DATE: JANUARY 8, 2020

ARC REVIEW CODE: R1912202

TO: Mayor Keisha Lance Bottoms  
ATTN TO: Monique Forte, Urban Planner III, Office of Mobility Planning  
FROM: Douglas R. Hooker, Executive Director  
RE: Development of Regional Impact (DRI) Review

**Name of Proposal:** The Works

DRI SITE PLAN

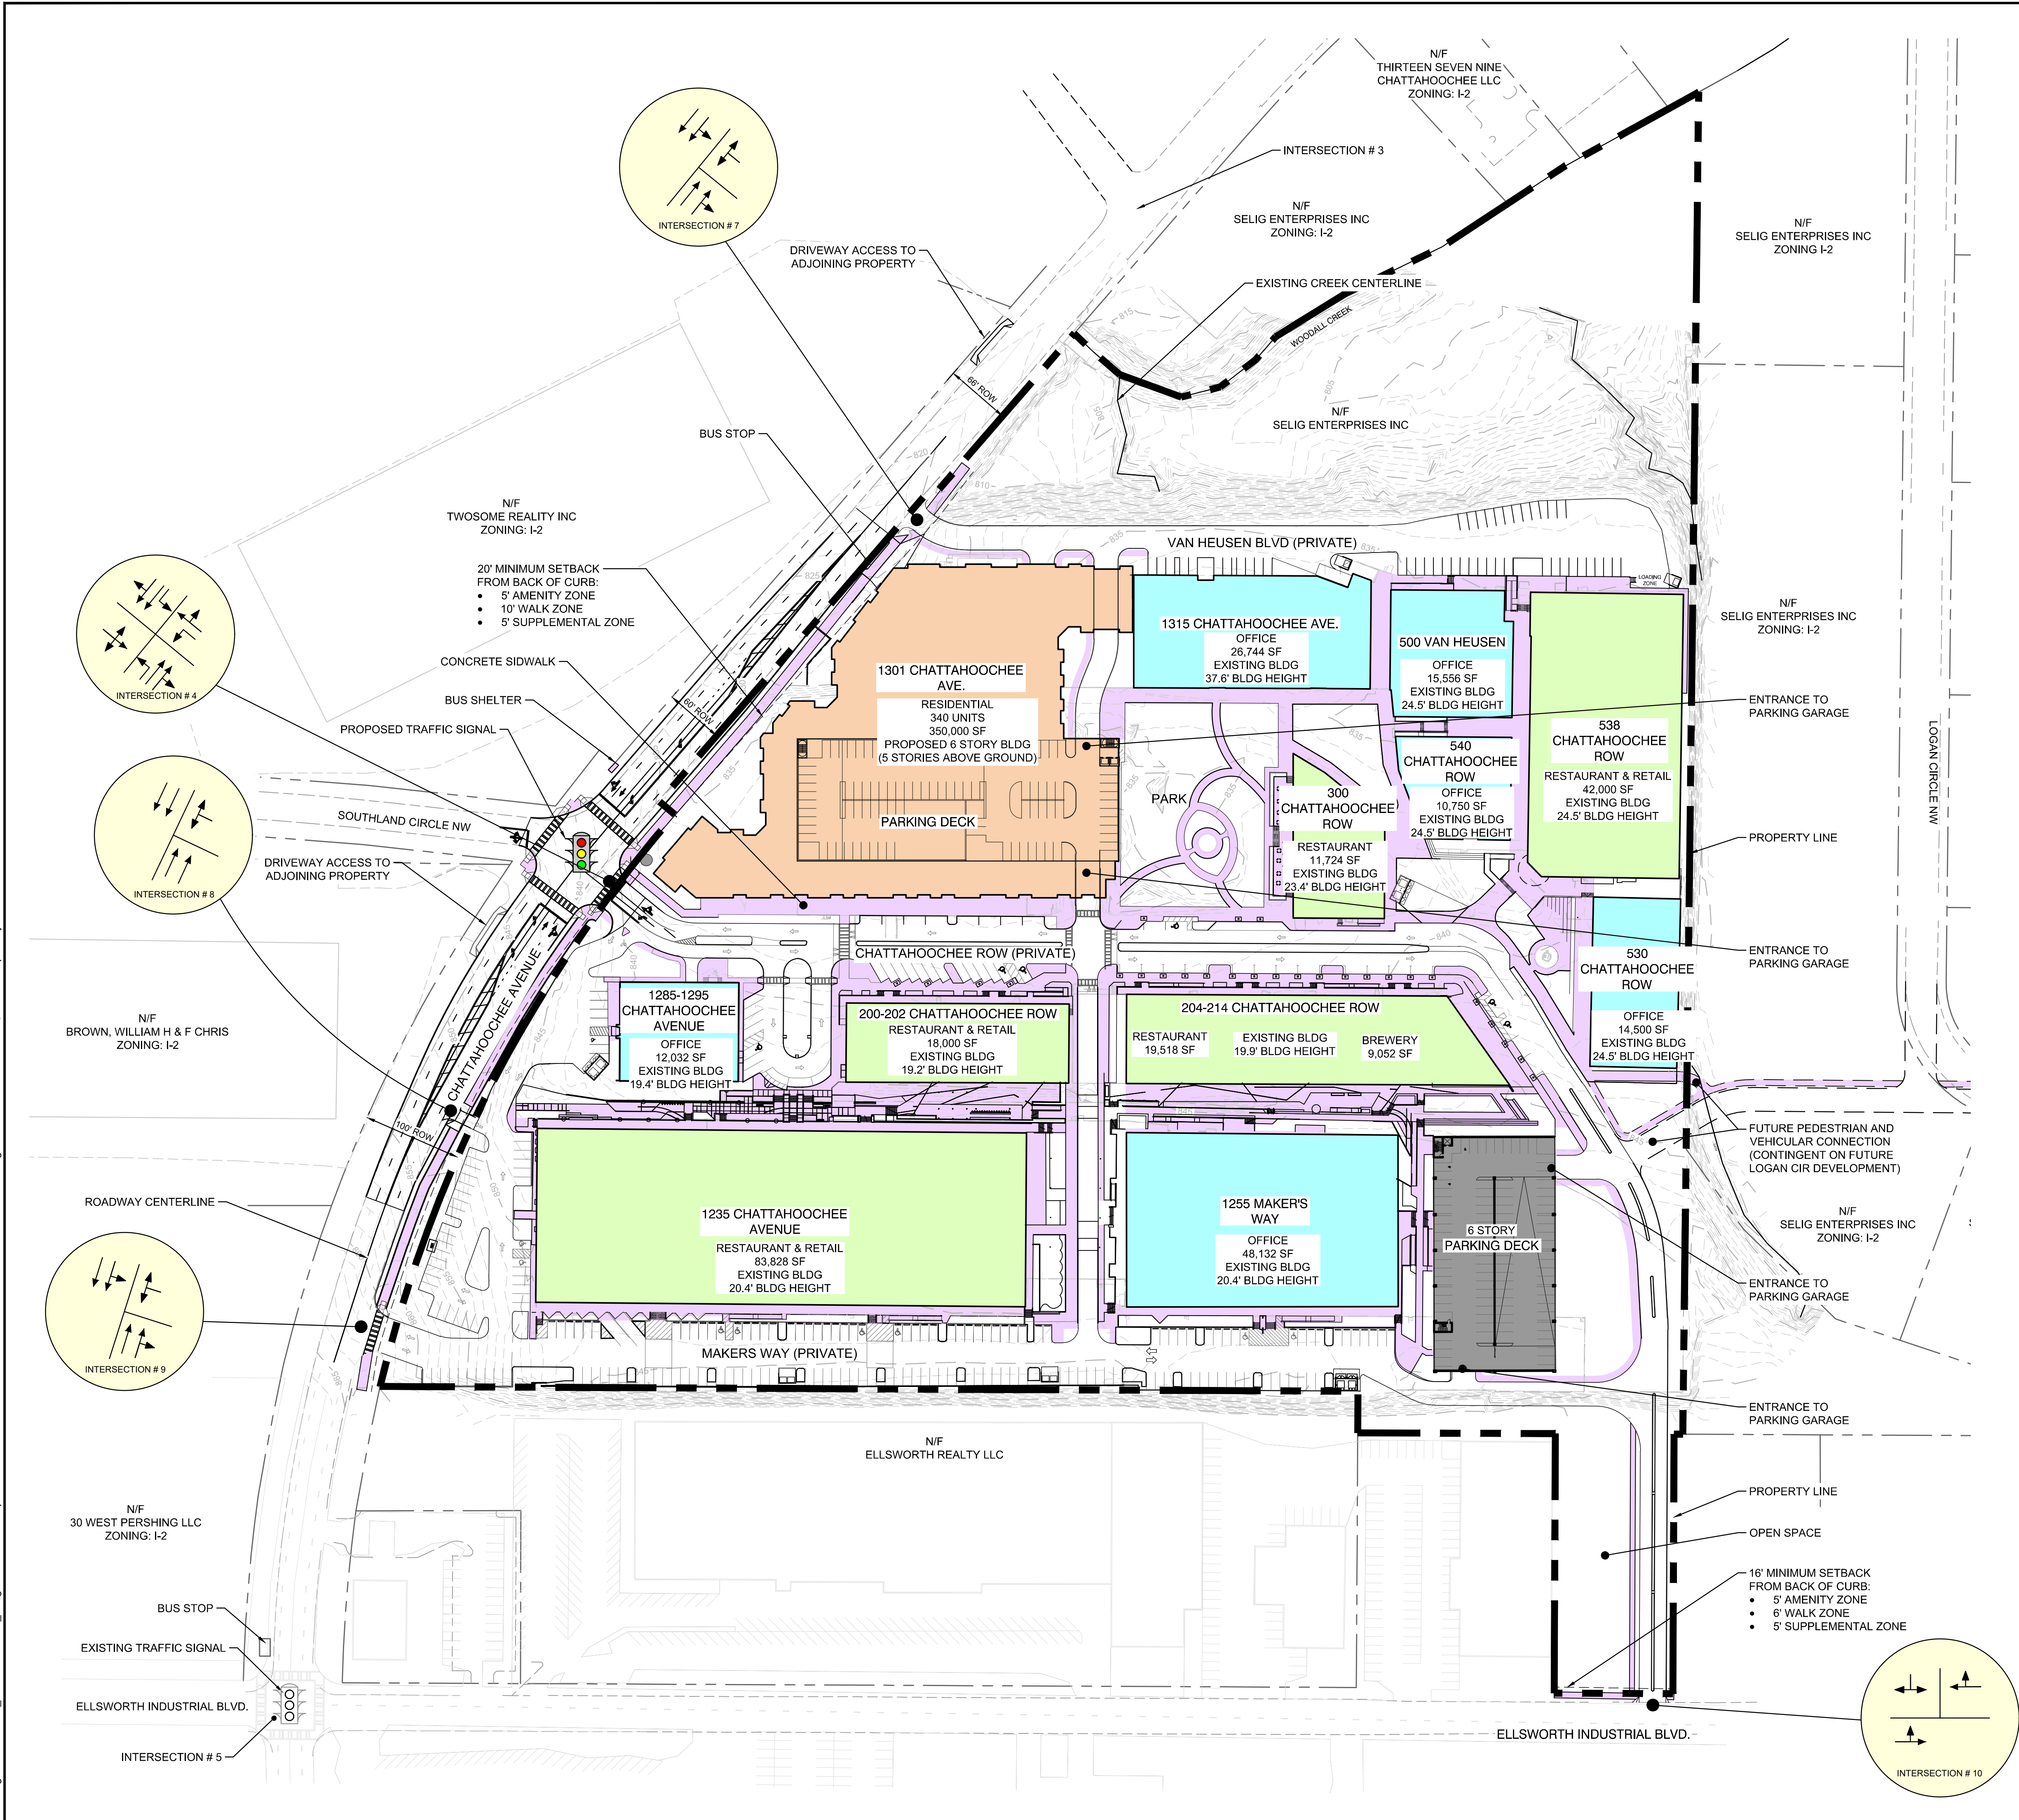
To capitalize on this potential, care should be taken to ensure that the development, as constructed, promotes an interconnected, functional, clearly marked and comfortable bike/pedestrian experience on all streets, paths, entrances, and parking areas. The development team is also encouraged to ensure that end-of-trip facilities are provided for residents, workers and visitors at key locations, e.g., scooter and bicycle storage racks throughout the site, lockers/showers in office spaces, etc. These recommendations are made

The applicant team should ensure that project driveways and intersections and any associated improvements (e.g., new turn lanes, traffic signals, etc.) are designed and implemented in full coordination with the City of Atlanta, to safely and efficiently accommodate the DRI's projected automobile traffic. Internal streets and driveways should be designed to minimize driving speeds and prioritize safety and comfort of pedestrians throughout the site, through the use of reduced lane widths, shorter curb radii, raised crossings, bulb–outs, and other design features. This project is notable for its potential to expand the street grid in the area, and future street connections should be preserved in the site plan.

The project can further support The Atlanta Region's Plan in general by incorporating other aspects of regional policy, including green infrastructure and/or low–impact design best practices throughout the site in general, in parking areas, on site driveways, in stormwater detention facilities, and as part of any improvements to site frontages.

The site plan depicts internal and external pedestrian facilities as a part of the development.

The site plan depicts sidewalks providing pedestrian connectivity to adjacent parcels.
